NEDO-33914-A, Revision 2,
BWRX-300 Advanced Civil Construction and Design Approach

BWRX-300 Advanced Civil Construction and Design Approach

SUBJECT: FINAL SAFETY EVALUATION FOR GE-HITACHI LICENSING TOPICAL REPORT NEDO-33914, REVISION 1, "BWRX-300 ADVANCED CIVIL CONSTRUCTION AND DESIGN APPROACH" (DOCKET NO. 99900003)

Figure 1-4: BWRX-300 Reactor Building Shaft Construction

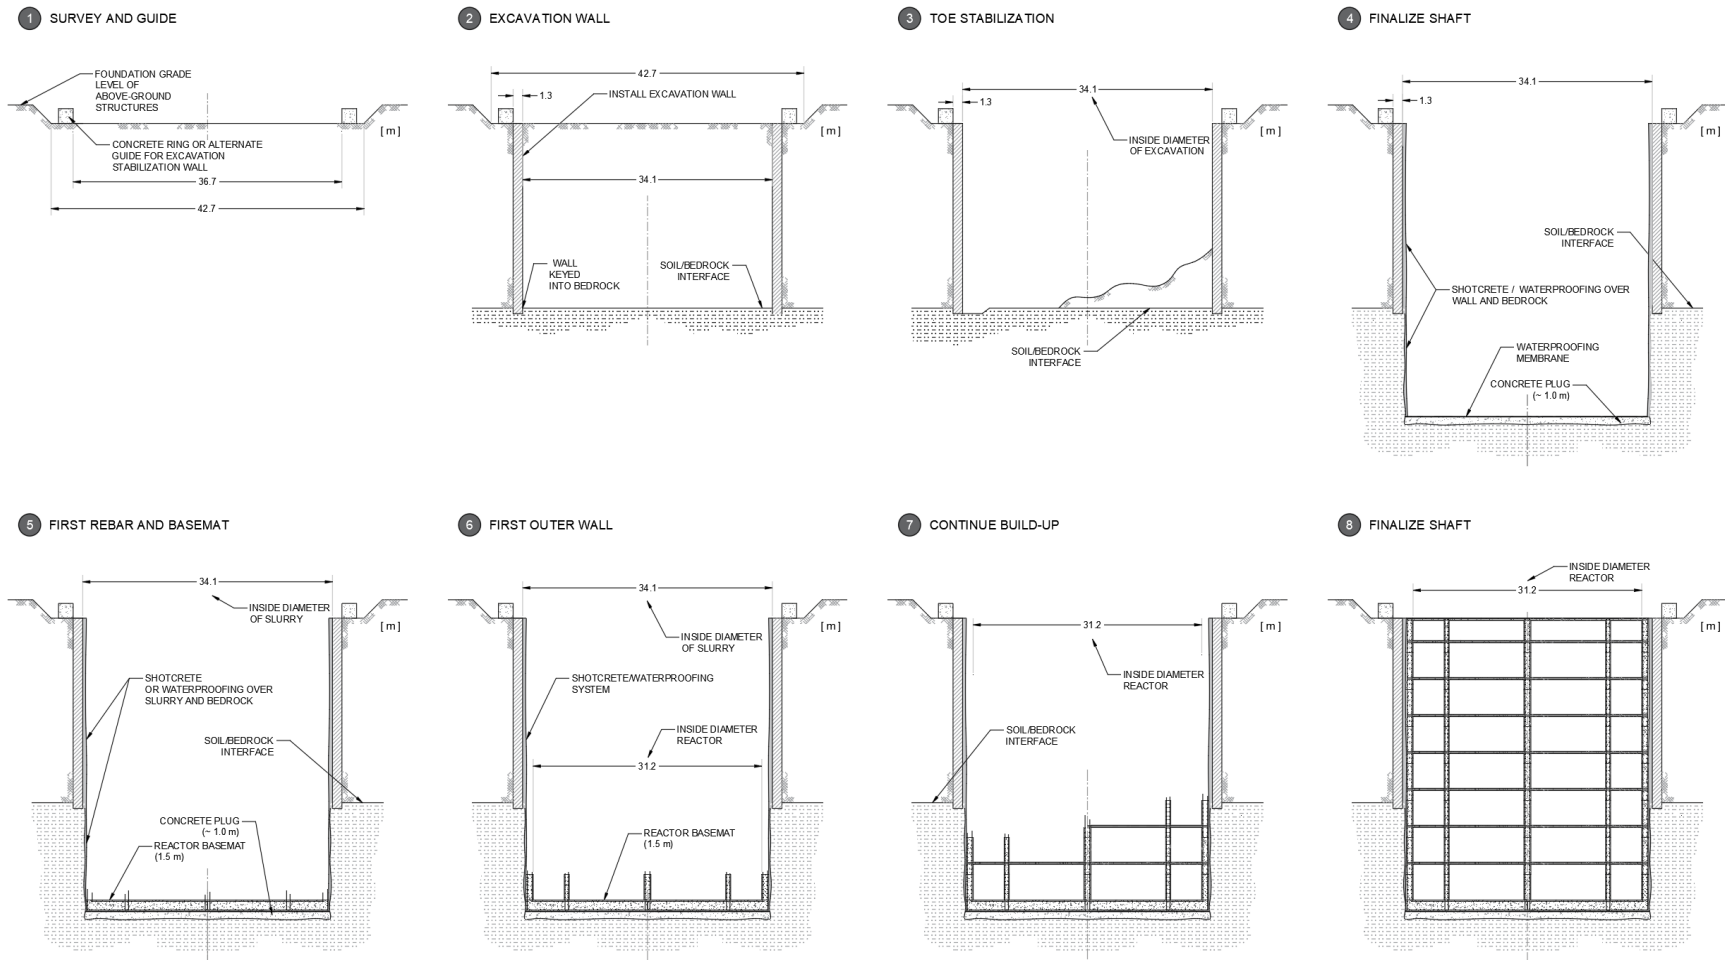
As shown in Figure 1-4 of NEDO-33914, the rock and soil media surrounding the Reactor Building (RB) shaft may not be accessible as the excavation progresses. Excavation support (e.g., slurry shoring wall or similar) will likely be needed for the RB shaft excavation that would make the soil inaccessible from the excavation. Depending on the subsurface conditions at a site, the rock excavation may be accessible for mapping beneath the soil excavation support. As described in Section 3.2.1 of NEDO-33914, mapping the walls and floors of the rock excavation during and at the completion of the rock excavation are intended to be the primary mechanism of confirming the assumptions made about rock media surrounding the RB shaft. Specifically, the orientation, joint characteristics, aperture, spacing, and persistence of the fractures used to characterize the rock mass could be confirmed. However, rock reinforcement, shotcrete, or waterproofing may limit access for mapping the rock excavation at some sites.

Figure 3-1: Preliminary Layout of the BWRX-300 Borings

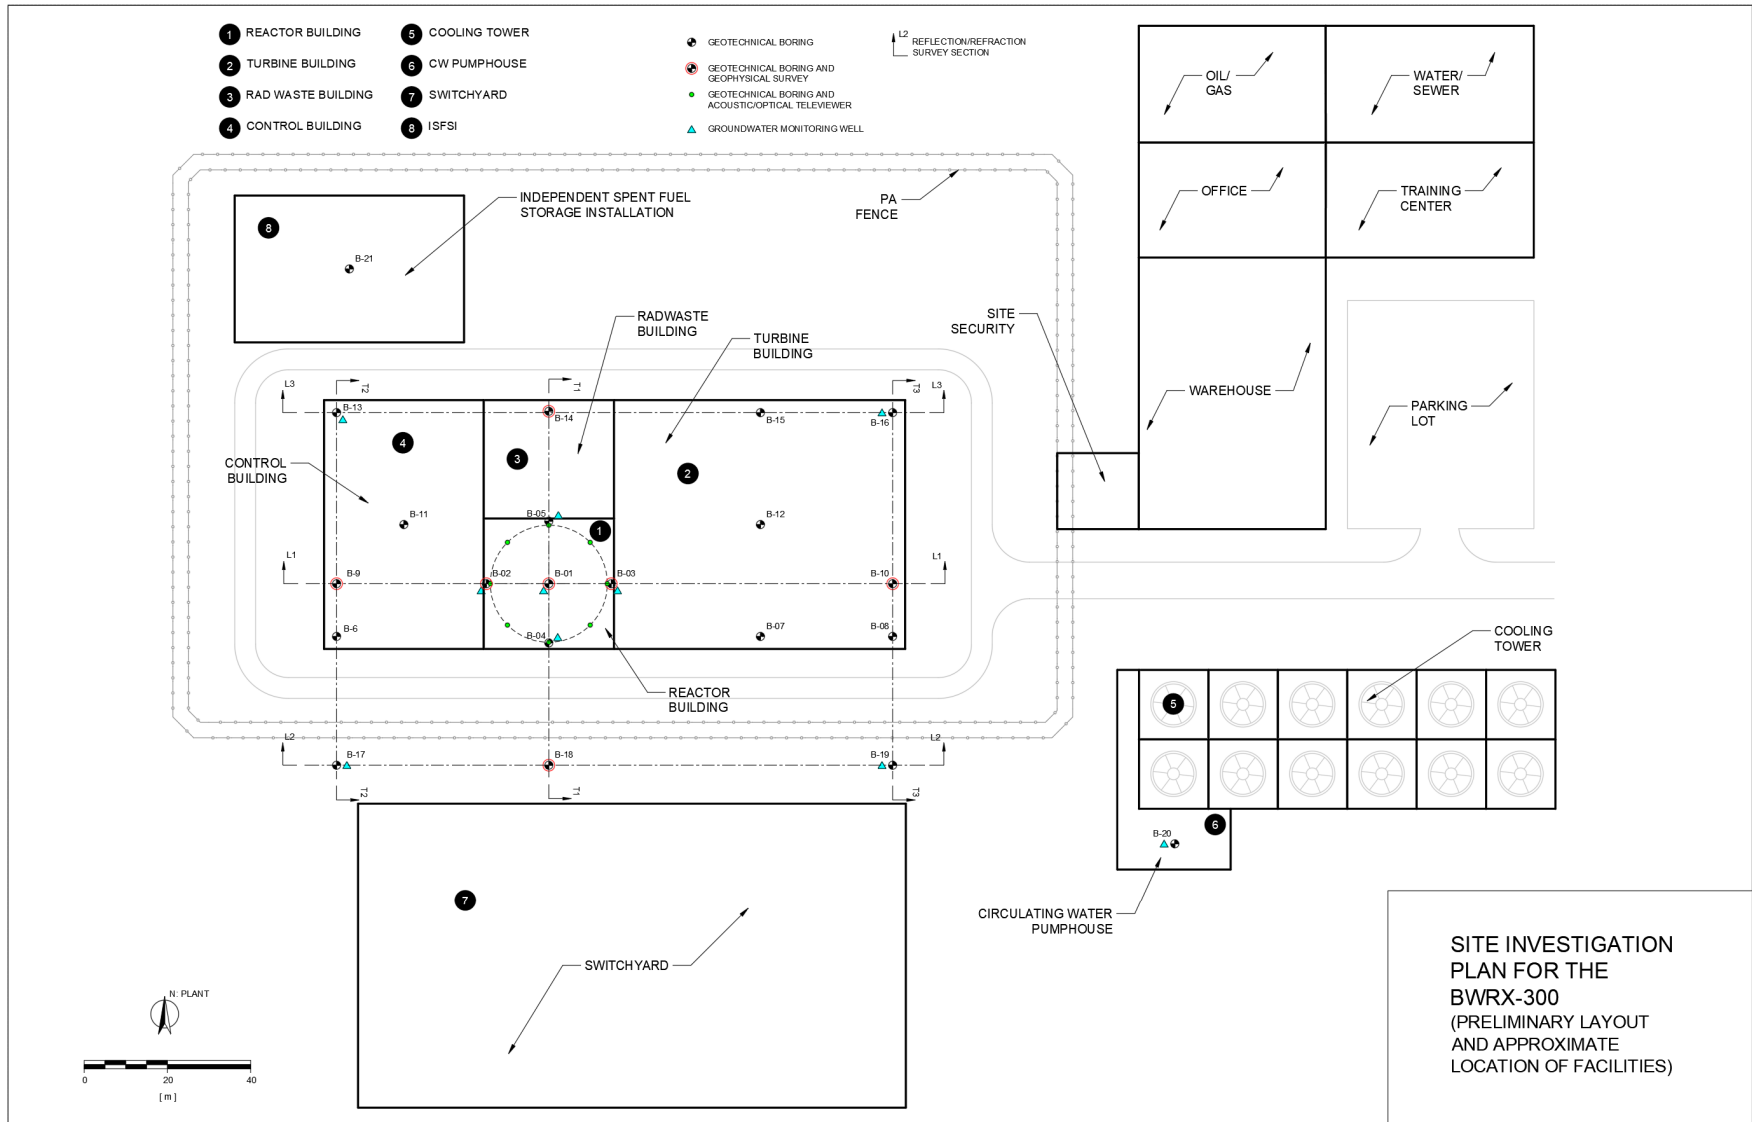
Figure 3-1 of the LTR shows a preliminary layout of the BWRX-300 SMR single unit plant and preliminary borehole locations for geotechnical and geophysical investigations for a typical site. Expected type and number of tests are given in Table 3-1. The LTR states in Section 3.1.1, that a minimum of 21 borings are anticipated for a BWRX-300 SMR installation, more than the recommended number of borings in Appendix D of RG 1.132 to ensure adequate characterization of the subsurface properties surrounding the RB structure. GEH has set the maximum required depth of these boreholes at approximately 120 m based on the change in in situ vertical stress.

The eight geotechnical boring/borehole televiewer locations are intended to collect a substantial amount of data on the perimeter of the potential RB shaft excavation (Figure 3-1 of NEDO-33914). This information would include the recovered soil samples and rock cores at the geotechnical boring in the center of the RB shaft and the recovered soil samples, recovered rock cores and borehole viewers at eight perimeter RB shaft locations to collect additional data on soil and rock properties. Geophysical surveys would also be completed in three of the geotechnical boring locations. The additional data are intended to provide substantial information on the soil and rock properties prior to excavating and sufficient information to compensate for limited inspections of the soil and rock mass when access is limited by the excavation methods.

Figure 3-2: Framework of Structures Monitoring and Aging Management Program

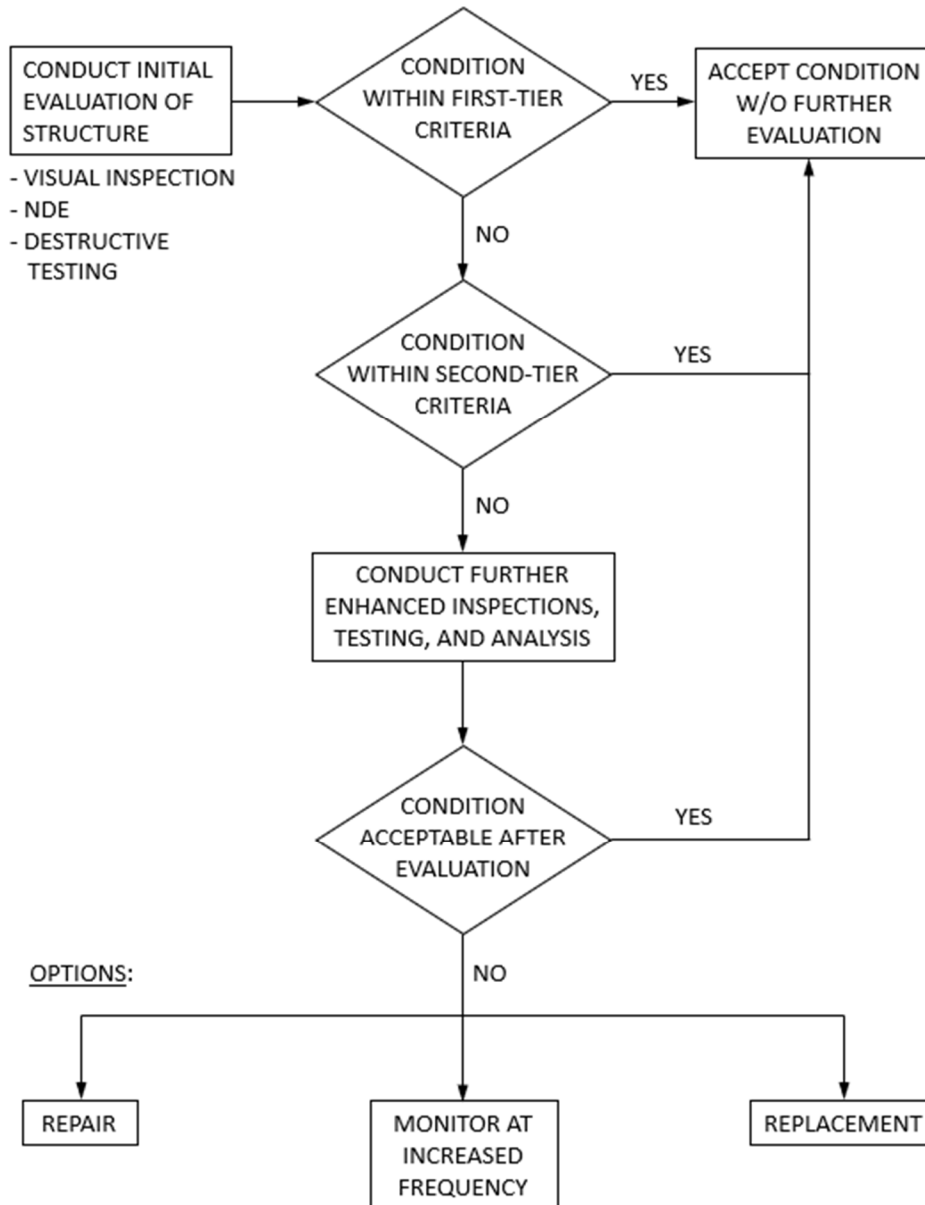
The LTR states that structural evaluation would follow the logic tree as shown in LTR Figure 3-2. The SMAMP has three tiers. In Tier 1, structures would be evaluated against qualitative and quantitative thresholds for visual inspections or condition surveys (First tier criteria) following Section 5.1 of ACI 349.3R. If a structure fails in Tier 1 evaluation, it would be subjected to Tier 2 evaluation. In Tier 2, structures would be evaluated against qualitative and quantitative thresholds for observed degradation in accordance with Section 5.2 of ACI 349.3R. Observed conditions failing the Tier 2 criteria would be evaluated to a Tier 3 evaluation. In Tier 3, structures would be evaluated using more enhanced methods to assess the structural condition. This evaluation would follow Section 5.3 of ACI 349.3R. Any corrective actions needed for a structure would follow the guidance given in Chapter 8, Repair, of ACI 349.3R. Provisions of the SMAMP would also include periodic sampling and testing of groundwater to assess whether the below-grade structures are exposed to an aggressive environment. If necessary, additional site-specific criteria would be developed.

The staff finds from the description of the SMAMP in the LTR that it would be designed following the national standard ACI 349.3R, and therefore the design of the program is reasonable. The definitions of the three tiers of evaluation follows ACI 349.3R. The logic tree for evaluation, as shown in Figure 3-2 of the LTR, is from Figure 5.1 of ACI 349.3R. The personnel conducting the evaluations shall be trained as per Chapter 7 of ACI 349.3R. Any remedial action needed would be in accordance with ACI 349.3R. The staff also finds that this section of the LTR is consistent with the provisions given in the latest version of ACI 349.3R, "Report on Evaluation and Repair of Existing Nuclear Safety-Related Concrete Structures," 2018. Based on the above, the staff finds that the description of the BWRX-300 SMAMP is reasonable as it is based on a recognized standard.

Figure 4-2: Interface Rheologic Modeling

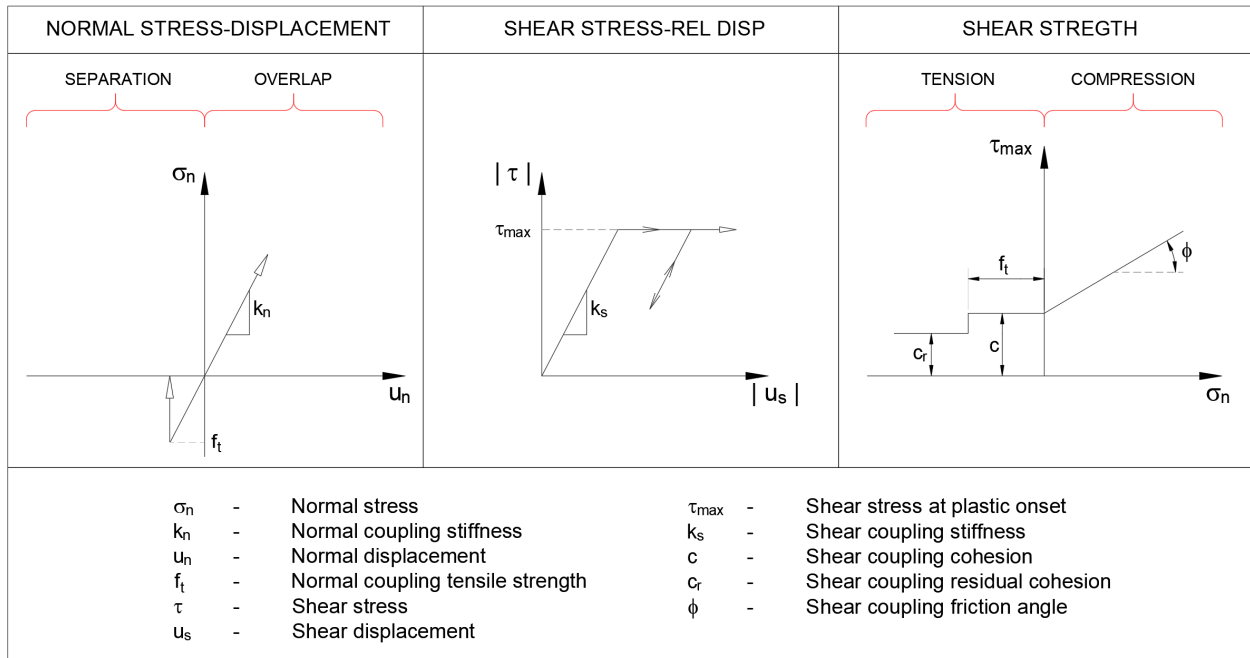
The LTR has provided the interface rheological model typically used with the BWRX-300 SMR in LTR Figure 4-2. Two sets of springs, one along and another across the interface, between two opposing sides of an interface are used as the interface element in the numerical model. The slippages along and opening/closing across the interface are controlled by these two springs. A series of these spring couplers would model the response of the entire interface. The relative sliding (shear) response of each spring along the interface is controlled by its stiffness. The LTR is proposing to use the elastoplastic Mohr-Coulomb criterion to model the shear behavior along the interface. The dilation/contraction or opening/closing of the interface is controlled by the normal stiffness of the spring and will be modeled using a tensile strength cut-off of the spring.

GEH has proposed that the parameters of the interface model, as shown in Figure 4-2 of the LTR, would be determined from the laboratory tests discussed in LTR Section 3.1.2. The LTR has also mentioned use of information collected in LTR Section 3.1.3, Characterization of Rock Mass Properties, to determine the interface parameters of the interface between the structure and the surrounding media. GEH, in response to the NRC Question 02.05.04-01, states that direct shear and/or triaxial test would be performed on rock discontinuity samples to estimate the interface properties.

The staff agrees with GEH that to model the natural discontinuities using the rheological model shown in LTR Figure 4-2 is reasonable because this rheological model has been used in numerous projects around the world and is commonly used in the mining and construction industries. The staff finds the proposal to estimate the model parameters from laboratory testing of samples of natural discontinuities, collected during field investigation at the site, reasonable as the parameters would be measured directly from samples containing actual discontinuities. The staff also agrees that the residual strength parameters of a natural discontinuity after small slippage would be smaller than the peak values. Strength reduction from the peak state to the residual state of the natural discontinuities is appropriate; however, the staff concludes that the minimum peak values of a set of discontinuities represent the peak value of the weakest discontinuity. The staff notes that in future licensing applications, the staff will review the parameters of the rheological model (Figure 4-2) of natural discontinuities from the laboratory tests. This review will address, as discussed above, the following items: (1) reduction of peak shear strength to residual shear strength of a discontinuity and (2) the minimum peak shear strength that is the shear strength of the weakest discontinuity in the discontinuity set.

Figure 4-2 shows the rheological model of an interface to be used in the Foundation Interface Analysis (FIA) with several parameters, such as, k_n , σ_t , τ_{max} , k_s , C , C_r , φ . These parameters determine whether the interface slides (shear failure) or dilates (tensile failure) under the imposed loads including the load from the safe shutdown earthquake (SSE). The response of both soil and rock media surrounding the Reactor Building (RB) shaft to the imposed loads significantly affects the loads imposed on the RB walls. In addition, the loads imposed on the RB wall may not be symmetric around the shaft walls, especially in the rock medium.

It is not clear from the discussions given in Site Investigation Program (Section 3.1.1) and Laboratory Testing Program (Section 3.1.2) whether a specific program would be developed to collect the necessary samples at the site and conduct specific tests at the laboratory to determine the parameters of the FIA model, as shown in Figure 4-2, or any other model to be used to represent

The sample collection and testing program for each site will be based on the presumed subsurface conditions. Depending on the selected software used for the FIA model, the sample collection and testing program will be adjusted to characterize the soil and rock parameters. Figure 4-2 in Licensing Topical Report (LTR) NEDO-33914 provides example interface models that could be used for the BWRX-300 FIA model. Interface models will be selected considering the specific site conditions and analysis requirements. NEDO-33914 provides the general design approach and appropriate guidance to develop these plans and programs following Regulatory Guide (RG) 1.132 (Reference 01-1) and RG 1.138 (Reference 01-2).

Figure 4-2 of NEDO-33914 provides an example model to simulate interactions at the RB wall/soil, RB wall/rock, soil/rock, and rock/rock interfaces. The model consists of two sets of elastic-perfectly plastic springs to simulate potential sliding and gapping at the interfaces. The properties for the interface model can be divided into strength properties, such as f_t , τ_{max} , c , c_r , and ϕ , and elastic stiffness properties, such as k_n and k_s . The strength properties are important because they determine the plastic deformations caused by either shear or tensile failures at the interface.

If the example interface model in Figure 4-2 of NEDO-33914 is not used, the site investigation and laboratory testing programs shall be modified to determine the parameters for the selected interface model.
